# DRAFT INITIAL STUDY / MITIGATED NEGATIVE DECLARATION BOLINAS WYE WETLANDS RESILIENCY PROJECT RESPONSES TO COMMENTS

September 29, 2023

Figure 1. Existing Conditions Velocity (fps) Map for the 1-Year Storm Event

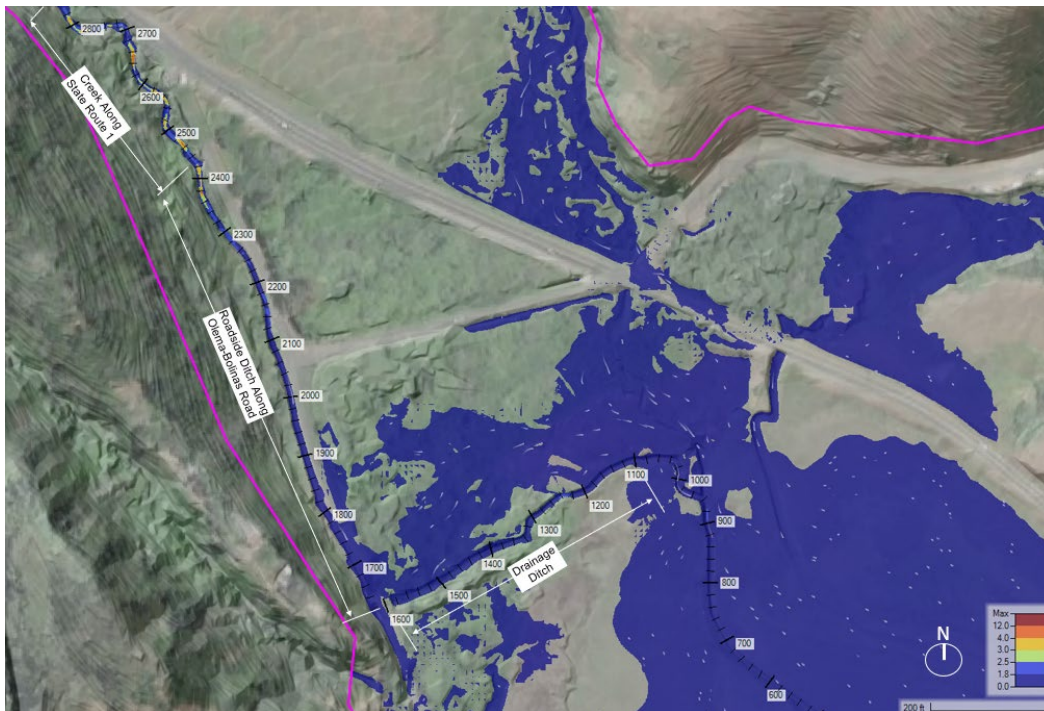
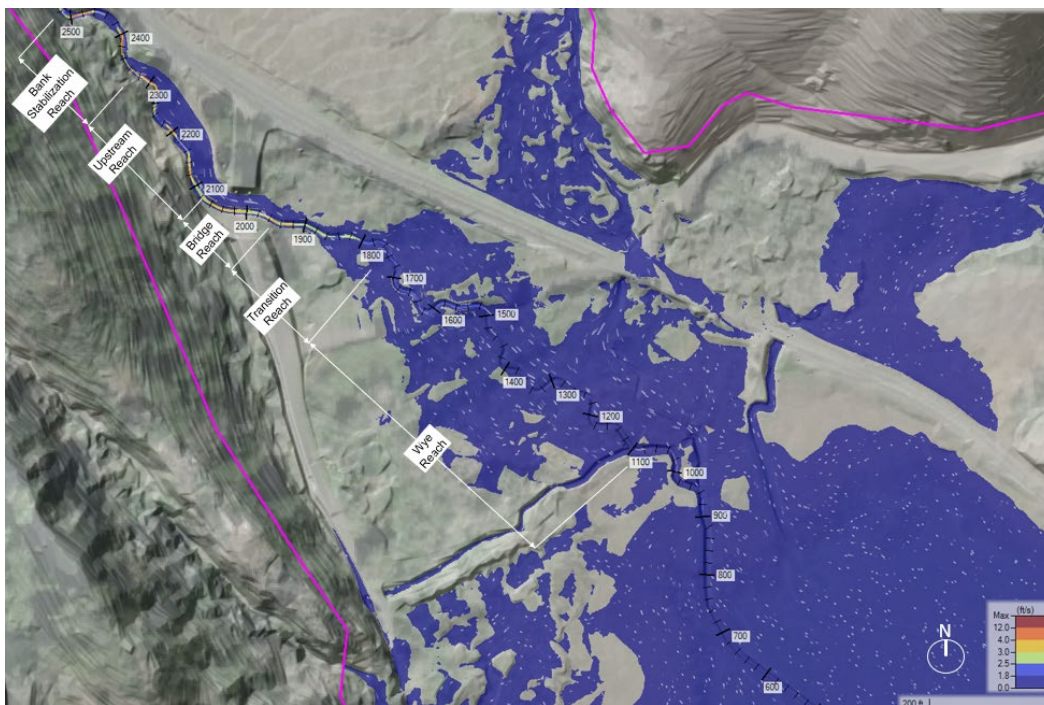
**Master Comment Summary: While roads may have some effect, other processes are responsible for the degradation of the watershed. Logging, land use practices upstream, and climate change are mostly responsible for the increase in sediment transport.**

While the roads may have some effect, the degradation of the watershed due to logging/land use practices upstream/climate change is mostly responsible for the increase in sediment transport. The sediment is going to settle out in its “happy place” depending on flow velocities/particle size/ and topography. The undersized box culvert at Lewis creek probably does not help but if the slope flattens out there it probably still will happen in that reach. Humans were just really good at building at these locations.

Figure 1 and Figure 2 demonstrate that the proposed Project will provide higher velocity as flows cross under Olema Bolinas Road to encourage deposition in the Wye reach during the 1-year storm event.

**Figure 9. Existing Conditions Water Surface Elevation (ft) Map for the 100-Year Storm Event with Predicted Sea-Level Rise by 2100**

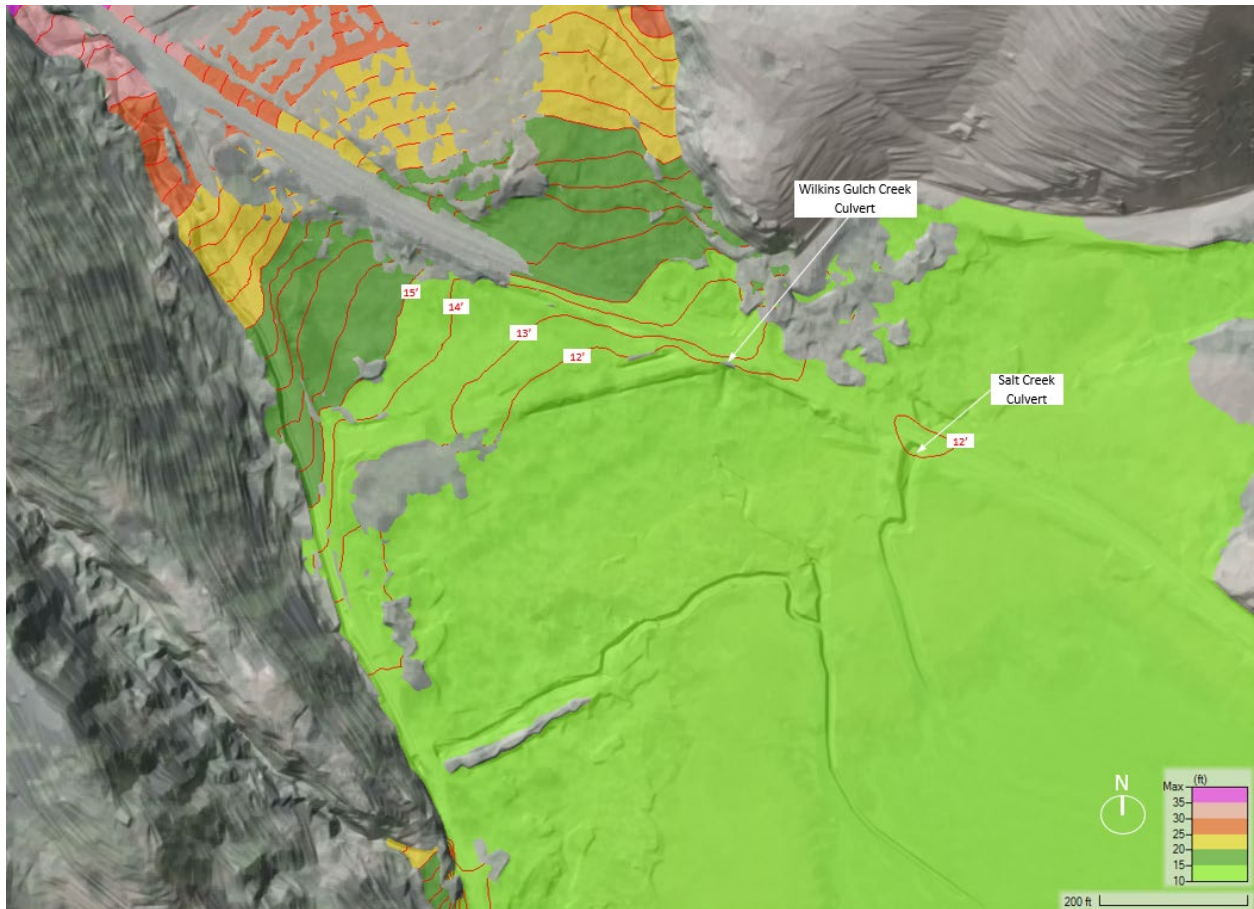
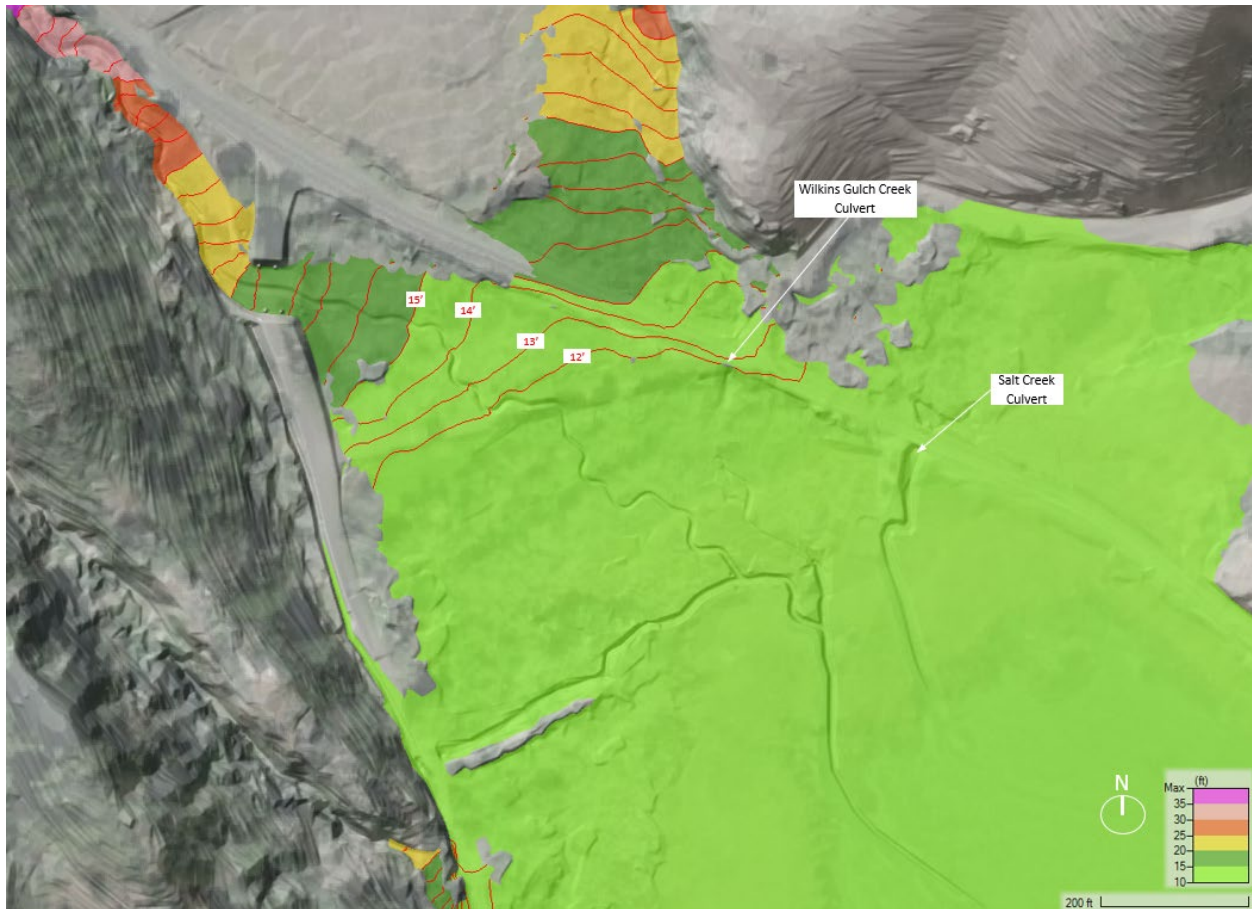
**Master Comment Summary: Corrections to reference the correct data in tables within this section. Recommendation to include discussion of the project's impact on SR-1 in the 100-year flow and various Sea-level rise scenarios. Recommendation to consider speed bumps and other measures to prevent negative environmental impacts on Horseshoe Hill Road and elevating the lower segments of Fairfax Bolinas Road.**

- In the second paragraph, the reference to the OPC's Table 1: Caltrans staff believe it should reference OPC's Table 13.
- Table 2 uses Sea-Level Rise Predictions of 2.0 feet and 5.5 feet, but OPC's Table 13 it appears these values should be 1.9 feet and 5.6 feet.
- The last sentence notes the project's benefit to Olema Bolinas Road. Similarly, Caltrans staff would recommend including a discussion of the project's impact to SR-1 in the 100-year flow and various Sea-Level Rise scenarios. Inclusion of a Figure (similar to Figure 18) that depicts flooding extent and depths for the existing condition (no improvements) with Sea-Level Rise scenarios would be helpful.

The modeling effort for the proposed Project determined that raising sea level (the model downstream boundary condition) to an elevation of 13.5 feet NAVD88 (7.9 feet of SLR above existing condition mean high water mark) would have no effect on the 100-year storm event at the proposed bridge related to water surface elevation, velocity, or shear stress. Therefore, the proposed Project accommodates a predicted sea-level rise of 5.5 feet per CO-CAT 2013 and a predicted sea-level rise 5.6 feet per OPC.

The sea-level rise modeling completed for the proposed Project shows post-Project and no-Project conditions with expected 2100 sea-level rise, showing no impact to the 100-year water surface elevation on SR-1 in the vicinity of the proposed Project. The two figures presented below illustrate these two scenarios. Figure 9 illustrates the existing condition water surface elevation with expected 2100 sea-level rise and Figure 10 illustrates the water surface elevation as it would occur with the proposed Project under the same scenario. Existing elevations of SR-1 southeast of the Project site along the Bolinas Lagoon range from 8 to 11 feet NAVD88. Model outputs show depths of flooding due to sea-level rise on SR-1 in this area ranging from 0 feet northwest of the Wilkins Gulch Creek culvert crossing to 3 feet deep at the Salt Creek culvert crossing. Post-project flooding levels would generally be similar, with flooding at the Salt Creek culvert being reduced as compared to no-Project conditions.
